re: Guenoc Valley Mixed Use Planned Development Project/ 22000 Butts Canyon Road, Middletown/
Lotusland Investment Holdings Inc.

Subject: Request for Review of the Guenoc Valley Mixed Use Planned Development Project:

1-LAK-29-6.36
SCH# 2019049134
Guenoc Valley Planned Development

Using District 1 Growth Factors Tutorial
2024 Growth Factor Summary
2024 Growth Factor Map

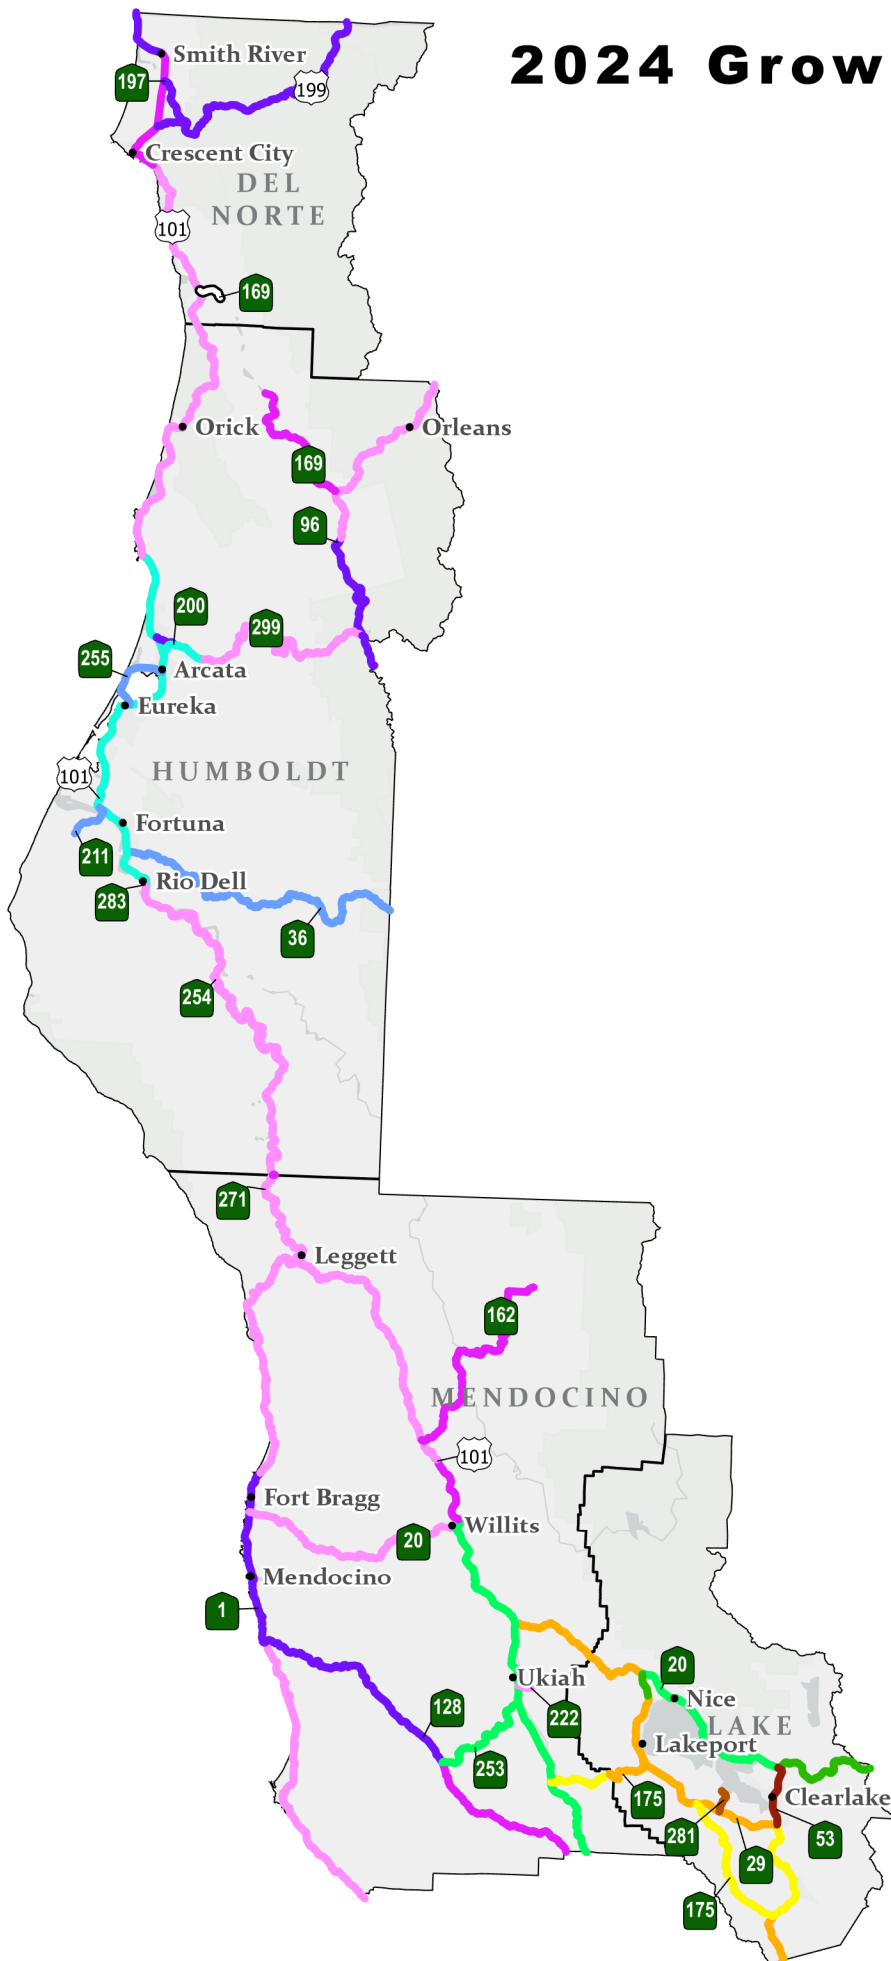
Our growth factors are applied over highway segments that were determined using observed conditions; these segments vary in length, but they are not longer than fifty miles. Traffic volumes over segments are based on a calculated weighted average to reflect volumes (Annual Average Daily Traffic) for the entire segment. While actual growth at the local level can vary considerably, we are looking at overall growth over the long-term. If more specific data or information are available for a particular location (actual counts, planned development, etc.) it may be advisable to calculate a location-specific rate. However, for the purposes of facility design (20-year, or greater, design-life) our generalized segment growth factors are appropriate. It should be noted that our growth factors forecast traffic growth only for the mainline (State Routes); local streets should be examined separately.

If you have any questions regarding the growth factors, please contact District 1 System Planning Branch.
